## ADDENDUM NUMBER 2

- 1.1 DATE: MARCH 4, 2010
- 1.2 PROJECT: CARDIOLOGY SUITE BELLEHARBOUR
- 1.3 PROJECT NUMBER: 1991.09
- 1.4 OWNER: SENTARA HEALTHCARE
- 1.5 ARCHITECT: PF&A DESIGN

**ASK1**

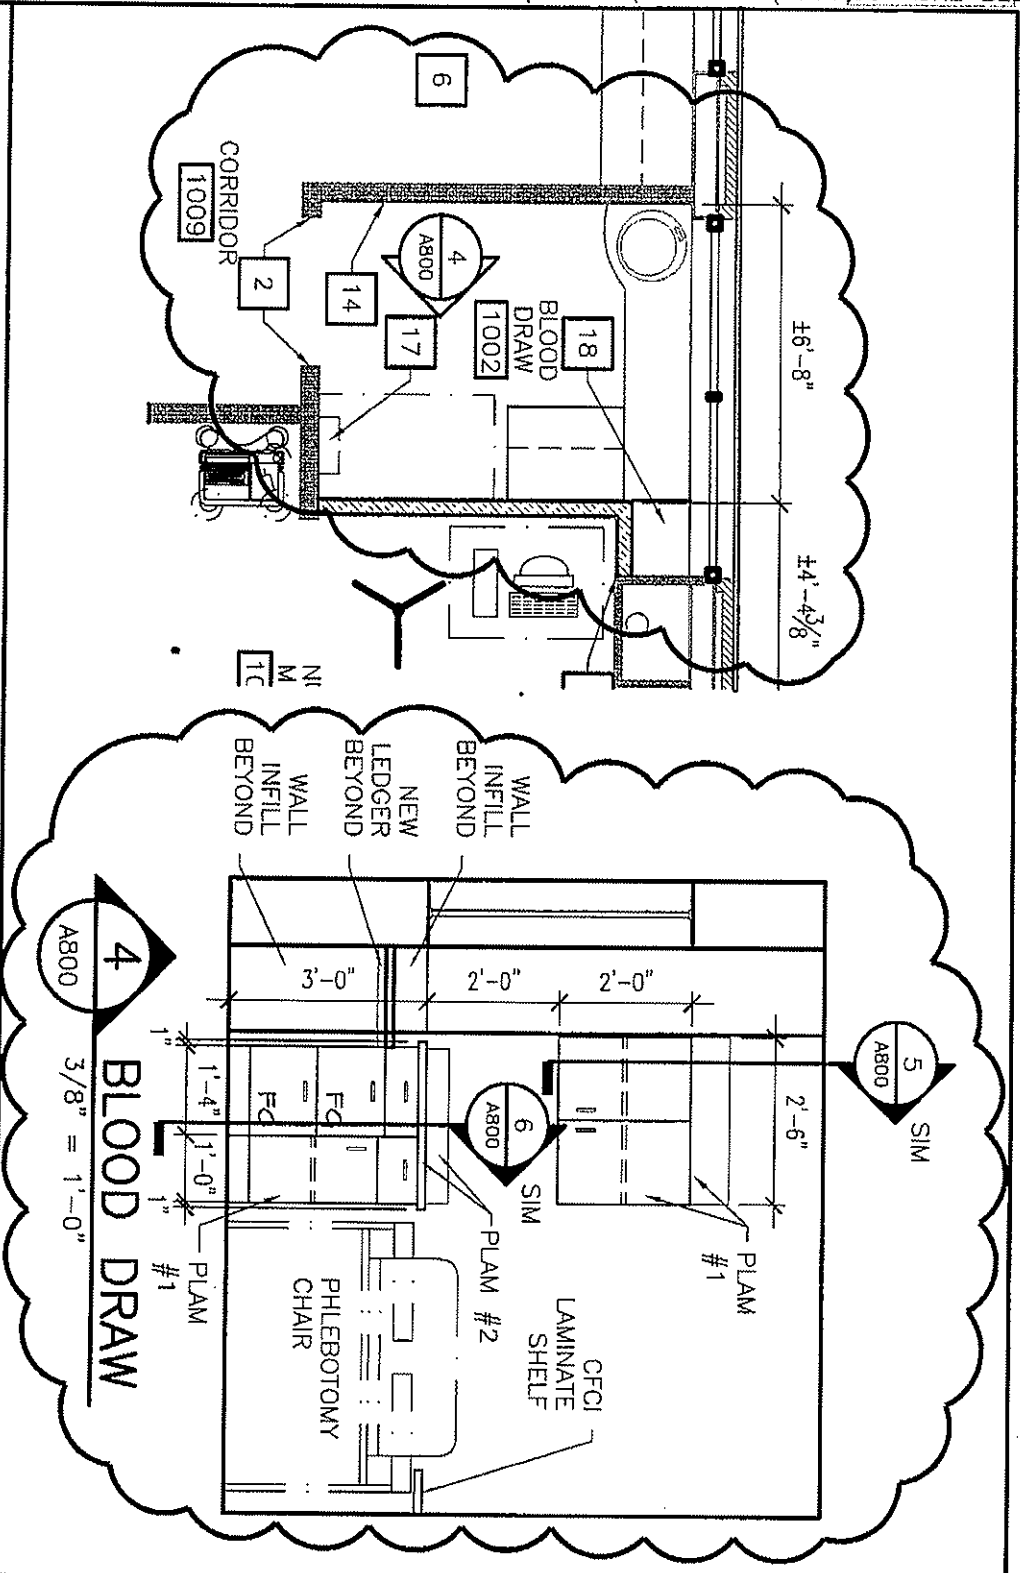
- C. Add "Turn over sink, faucet and fittings to Owner" to Demolition Note #6
  - D. In New Work Plan provide corner sink to room 1001 and install OFCI paper towel and soap dispensers. **See attached sketch ASK1**

**ASK2**

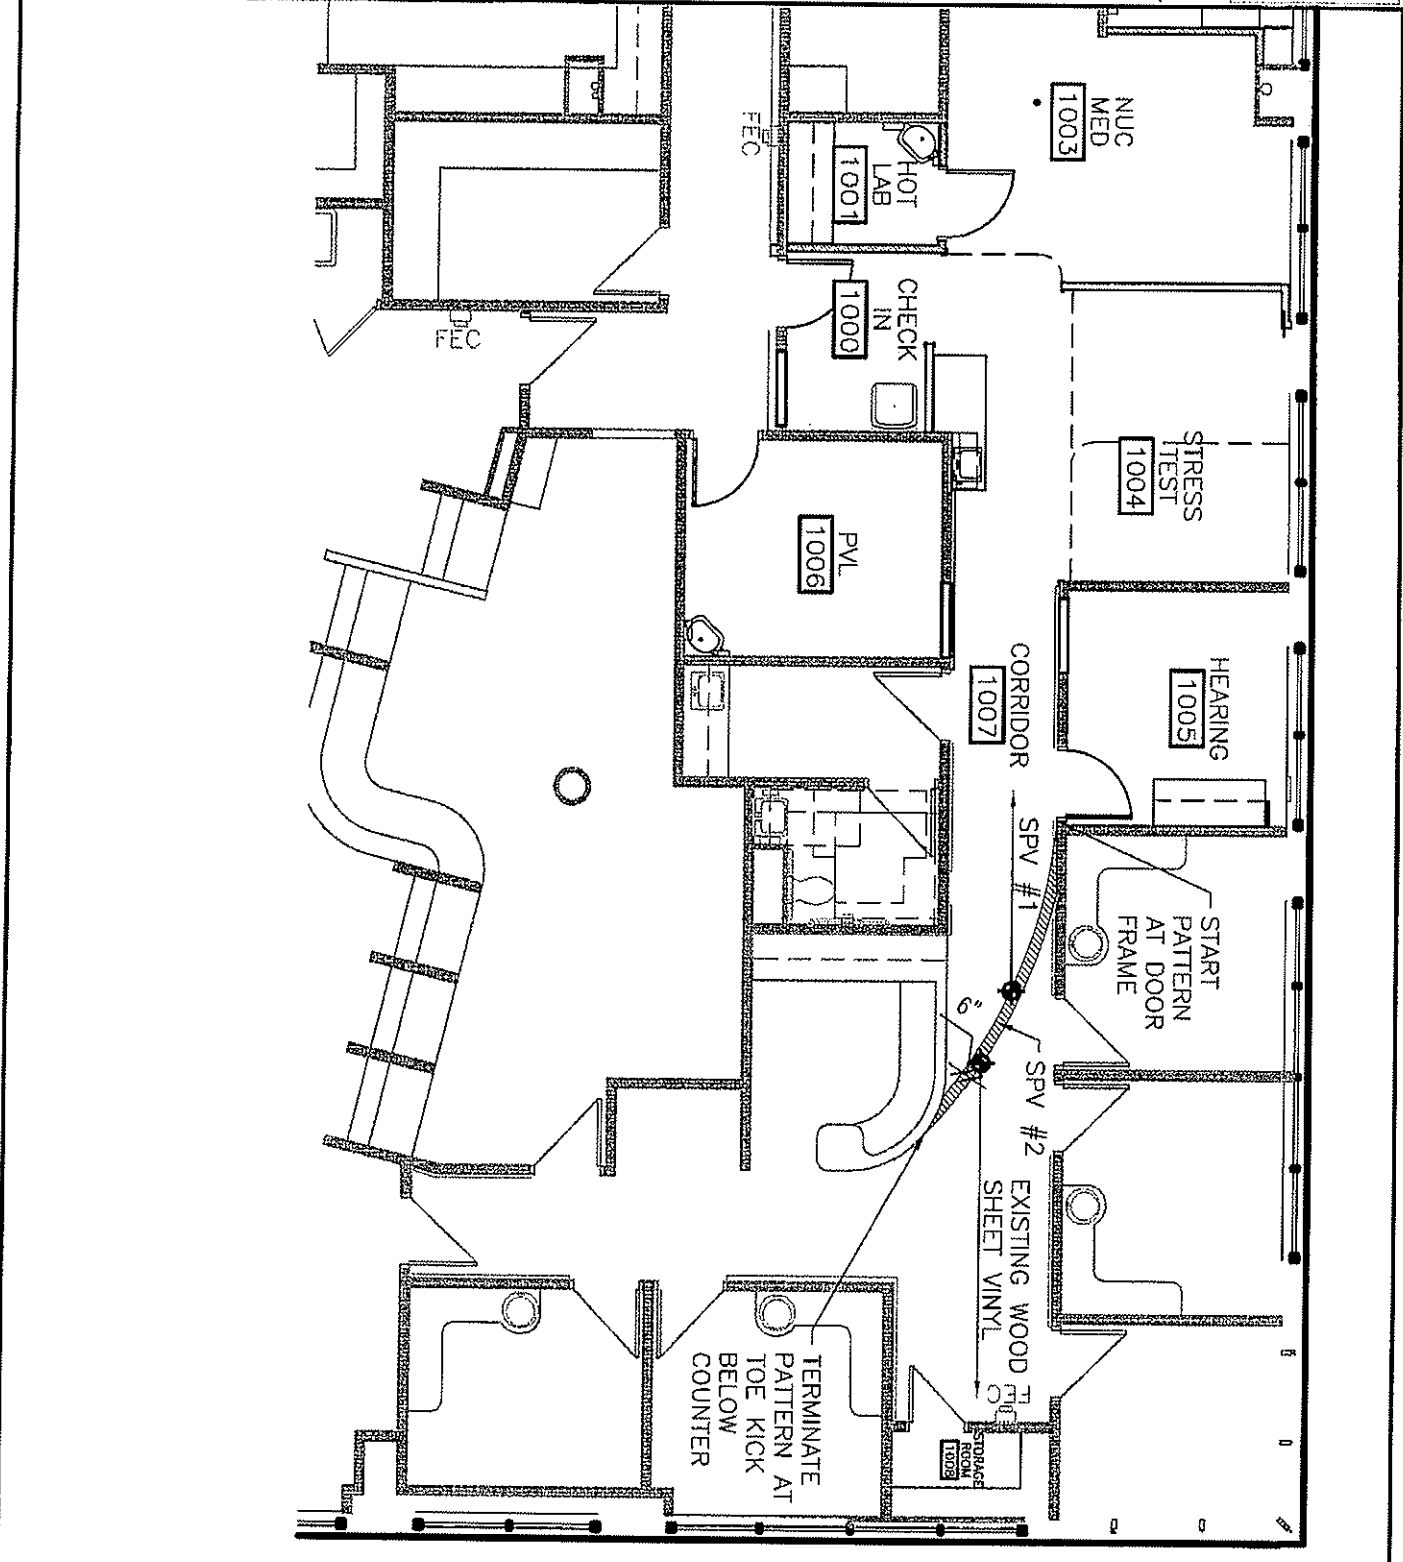
- E. In New Work Plan room 1002: Rework existing solid surface counter and provide wall infill as indicated in New Work Note #18. **See attached sketch ASK2**

- F. In New Work Plan room 1002: Provide white melamine shelf as indicated in New Work Note #17. **See attached sketch ASK2**
- 3.2 DRAWING A210 - Reflected Ceiling Plan, Door and Finish Schedules, And Details

- 3.3 DRAWING A800 - Casework Elevations and Sections
  - A. Elevation 4/A800 Provide file cabinets with 12" base cabinet below counter adjacent to existing countertop. **See attached sketch ASK2**

- 17. PROVIDE SMALL WHITE MELAMINE SHELF WITH SUPPORT BRACKETS. PROVIDE SIZE, INSTALLATION HEIGHT AND BRACKETS TO MATCH EXISTING ADJACENT.
- 18. REMOVE EXISTING SOLID SURFACE COUNTER TOP, SINK AND FILE CABINET BELOW. PROVIDE NEW WALL AT EDGE OF EXISTING COUNTER. INFILL CORNER AT WINDOW SILL HEIGHT WITH M3B TYPE WALL TO EXTEND TO AND ALIGN WITH EDGE OF NEW WALL AND EXISTING COUNTER. PAINT TO MATCH WALL COLOR. REINSTALL SOLID SURFACE COUNTERTOP WITH LEDGER AT NEW INFILL CORNER. REINSTALL FAUCET AND SINK. DISCARD FILE CABINET AND EXISTING END PANEL. SINK CABINET WILL REMAIN BELOW COUNTERTOP WITH OPEN SPACE BETWEEN SINK CABINET AND WALL BELOW WHEN COMPLETE.

**ASK3**

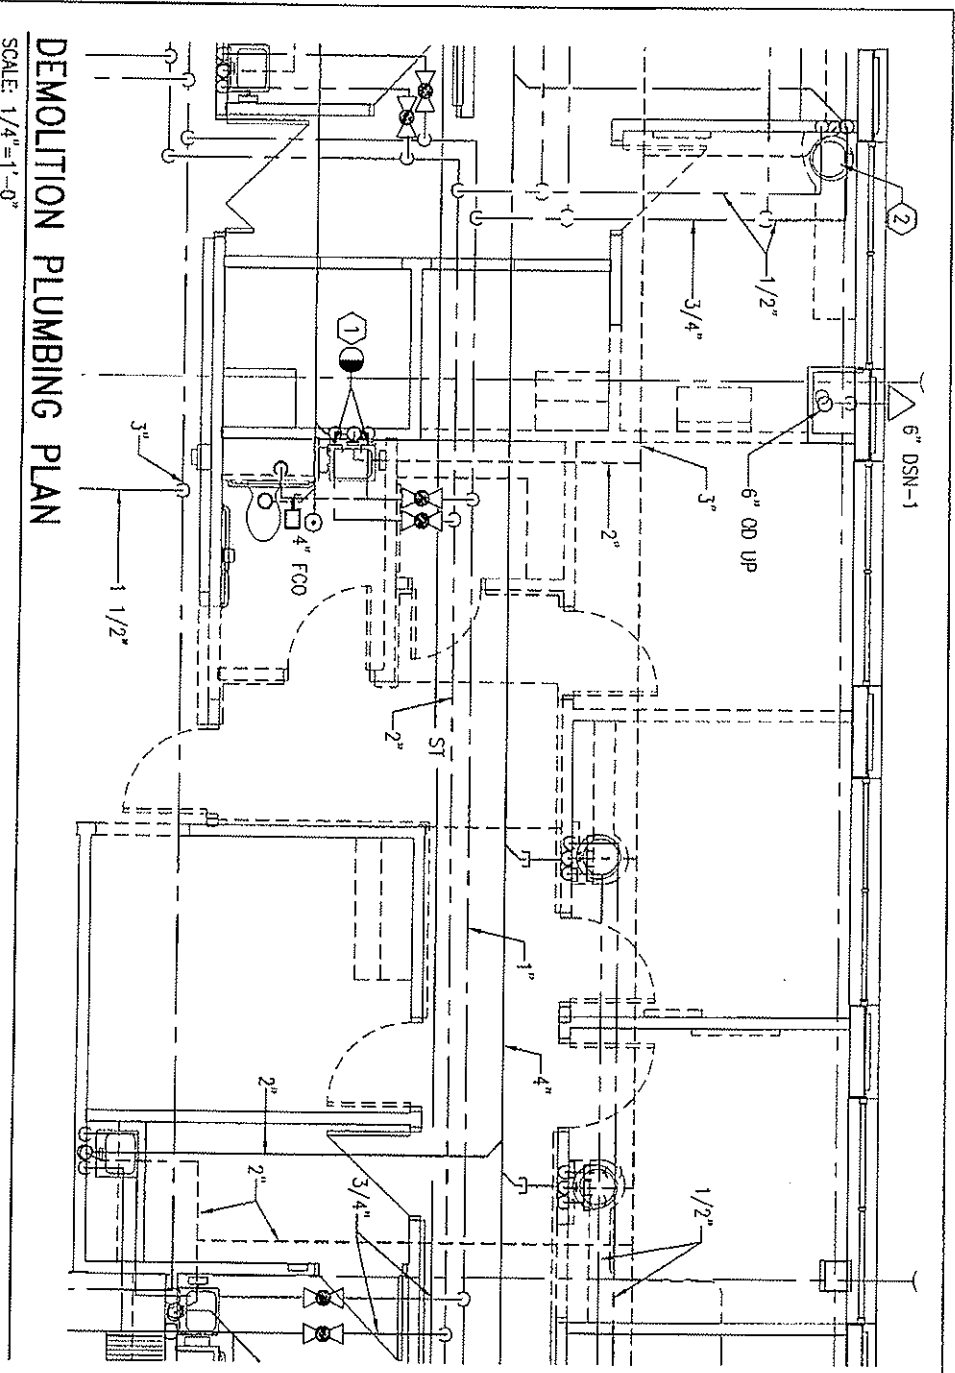
- A. Remove SV #1 from Finish Colors - NOT USED
  - B. Add SPV #2 to Finish Colors: Parterre #T-900 "Classic Walnut" **See attached sketch ASK3 for Floor Pattern Plan**

**SKP-1**  
 1 OF 2

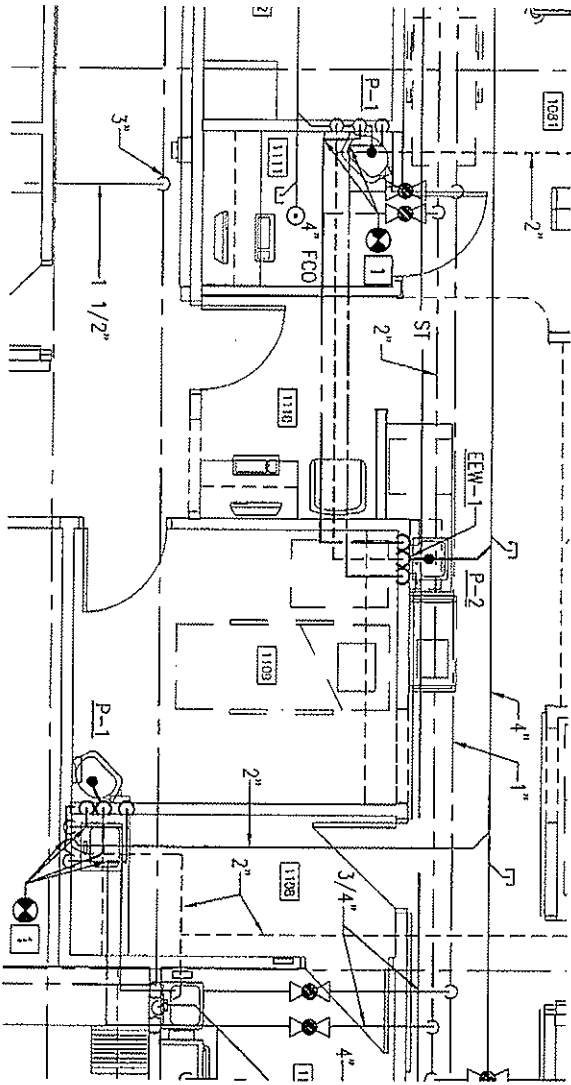
- A. Demolition Plumbing Plan revise demolition note #1 for future connection and add note #2 to retain sink and rework for casework modifications as indicated on plan. **See attached sketch SKP-1**
- B. New Work Plumbing Plan revise New Work Note #1 for new sink at room 1001. **See attached sketch SKP-1**

1. REMOVE EXISTING HW AND CW SUPPLY TO ABOVE CEILING, CAP AND RETAIN FOR NEW FIXTURE CONNECTION.
2. RETAIN WASTE AND VENT PIPING. SEE SKP-2 FOR NEW FIXTURE LOCATION.
3. RETAIN EXISTING SINK TO ACCOMMODATE NEW CASEWORK MODIFICATIONS. SEE ARCHITECTURAL DWGS. FOR NEW CASEWORK.
